Release Note

Edgecore EAP105 Release v12.6.3 Document # EAP105-v12.6.3-2386-73ec2ed0-d9c6975

Enhancement from v12.6.1-2327-d27a7cb9-390f4d7

1.1 Support WPA3 Enterprise in OpenRoaming

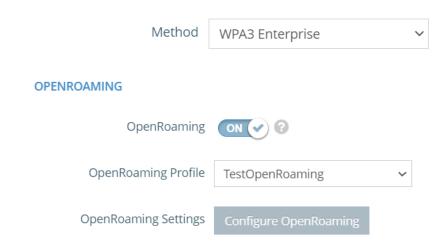
Support WPA3 Enterprise in 2.4GHz, 5GH, and 6GHz OpenRoaming.
